SERVICE BULLETIN

ENGINE — FAN SPEED/TRIM BALANCE PROBES ELECTRICAL HARNESS —
INTRODUCTION OF A NEW PART NUMBER

BULLETIN ISSUE SEQUENCE
V2500 Series 72-0696

V2500-ENG-72-0696

LOCATION OF THE NF ELECTRICAL HARNESS
72-32-37
FIGURE 1

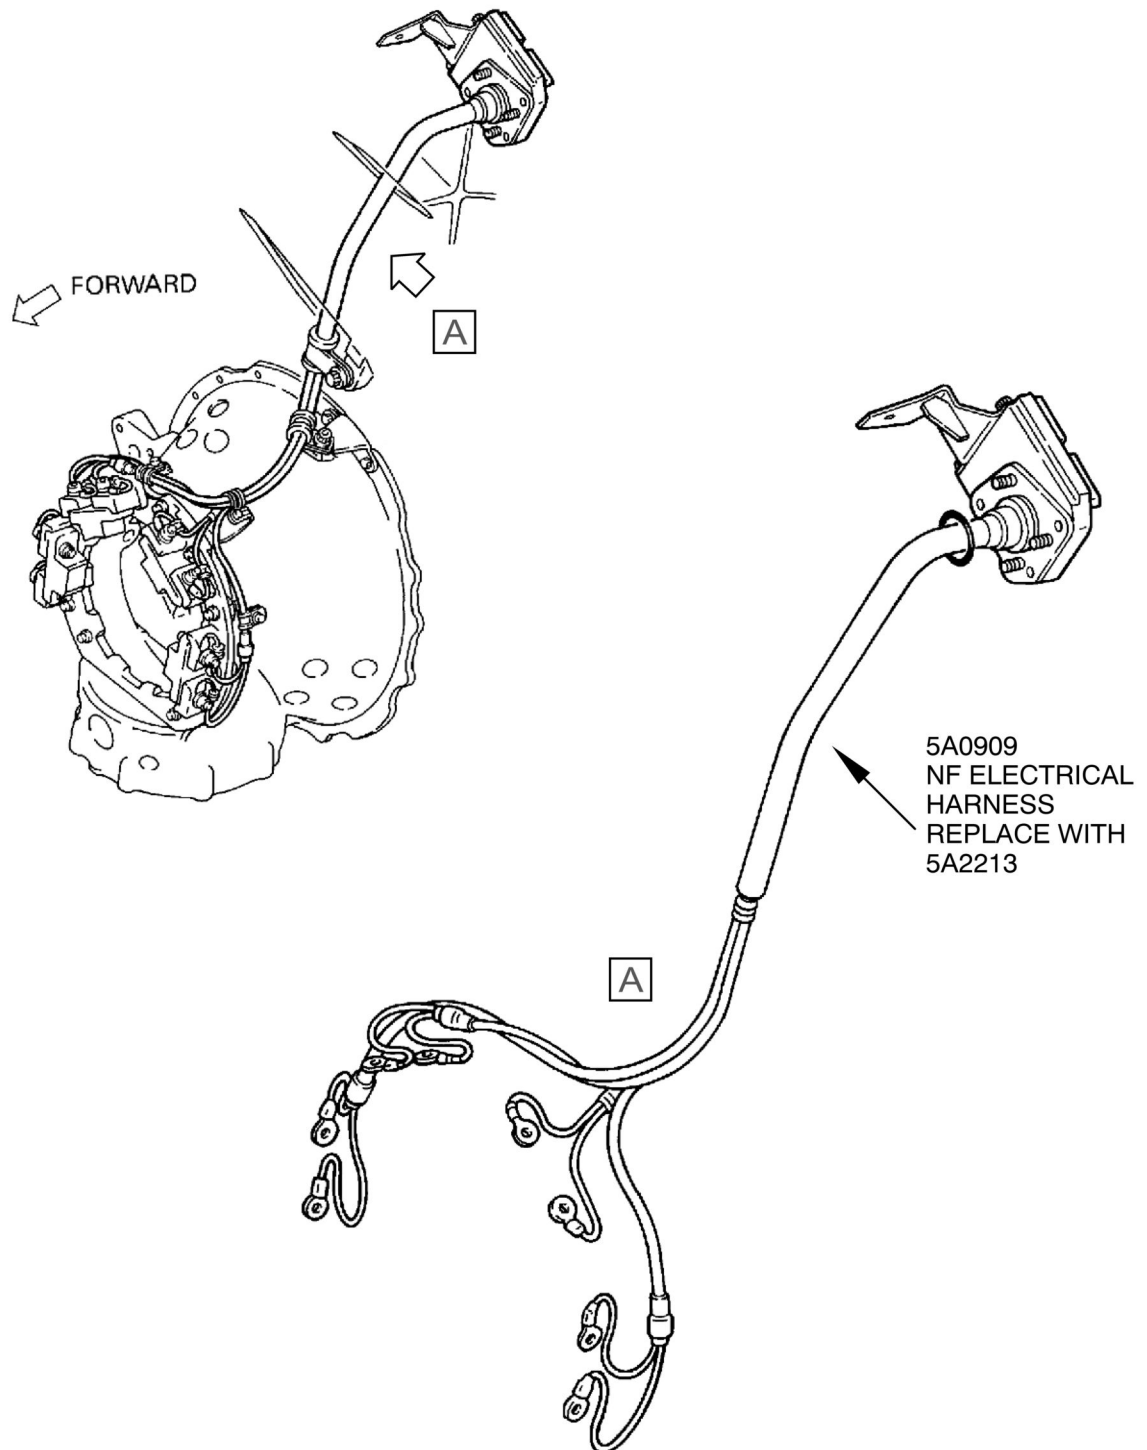
1. Replace the NF Electrical Harness, PN 5A0909 with PN 5A2213, as specified in Reference 5, Engine Manual, Task 72-32-00-030-012 and 72-32-00-430-004. See Figure 1.
2. Recording Instructions
 - A. A record of accomplishment is required.

NF ELECTRICAL HARNESS
CHART A

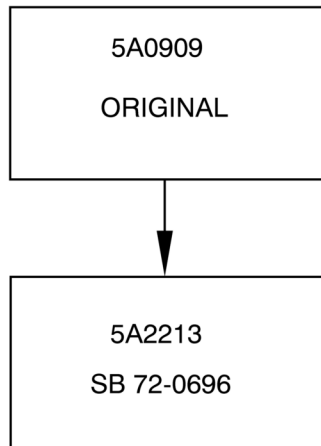
Parts Progression To Show the Changed Part in Relation to Other Parts
